***MAJOR PROJECT ASSESSMENT:
Bamarang Gas-Fired Power Station
(Stage 2)***

Director-General's
Environmental Assessment Report
Section 75I of the
Environmental Planning and Assessment Act 1979

October 2008

Figure 4: Worst Case Noise Predictions (With Mitigation)

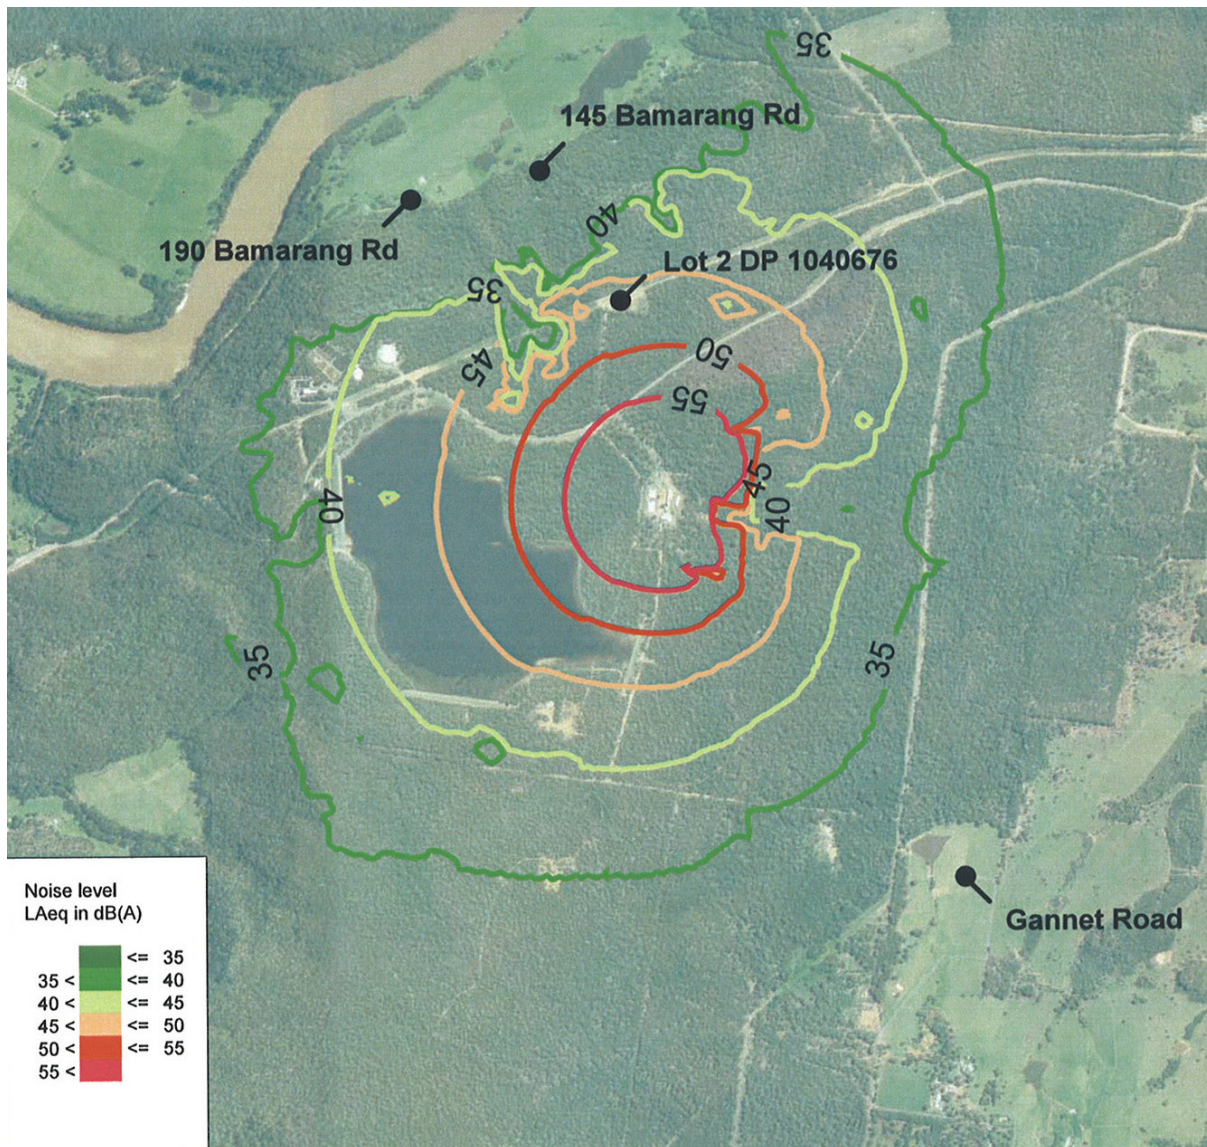
All of the public submissions received raised concerns regarding the potential noise impacts of the Stage 2 project including concerns that the modelling undertaken was not representative of local meteorological conditions and of all surrounding sensitive receivers. Shoalhaven Council raised concerns regarding the potential impacts of the Stage 2 project on the new living areas identified in the Nowra Bombaderry Structure Plan (endorsed following the approval of the concept plan and Stage 1). DECC required further clarification of mitigation options to demonstrate that the stated noise goals could be achieved.

The Department is satisfied that the noise assessment has been undertaken in accordance with the *NSW Industrial Noise Policy*, including consideration of worst case operating scenarios and meteorological conditions and the modelling is representative of noise conditions to nearest sensitive receivers. The Department is further satisfied that the mitigation measures proposed by the Proponent are viable and feasible options that can be implemented as part of the Stage 2 facility to ensure that appropriate noise goals are achieved. Consequently, the Department is satisfied that the revised Stage 2 project (incorporating air-cooled condenser technology), would not result in unacceptable noise impacts to existing sensitive receiver, consistent with the approved concept plan.
